## REMARKS

### Drawings

Annotated Marked Up Drawing

FIG. 6

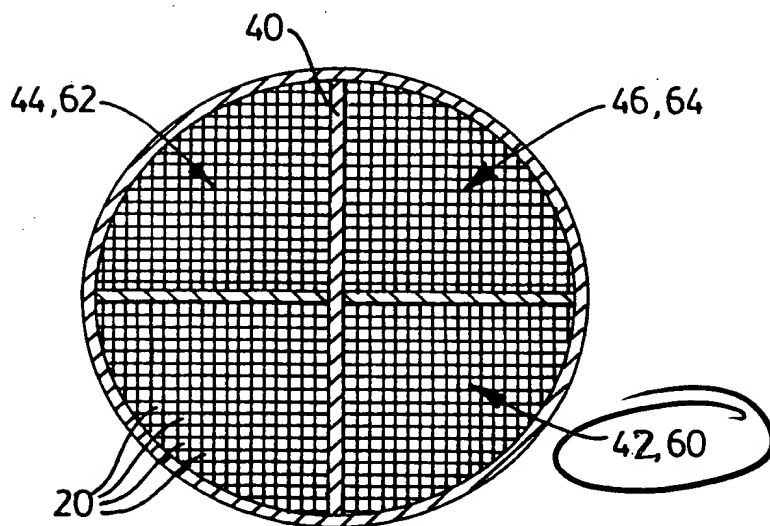
Figure 6 has been amended as requested by the Examiner to change reference numeral "43" to --42--.

The Applicant encloses an amended set of drawings each of which is labelled "Replacement Sheet" in the upper margin for substitution for the drawings presently of file. A further copy of the page containing Figure 6 is enclosed and labelled "Annotated Marked Up Drawing" to illustrate the amendment to Figure 6.
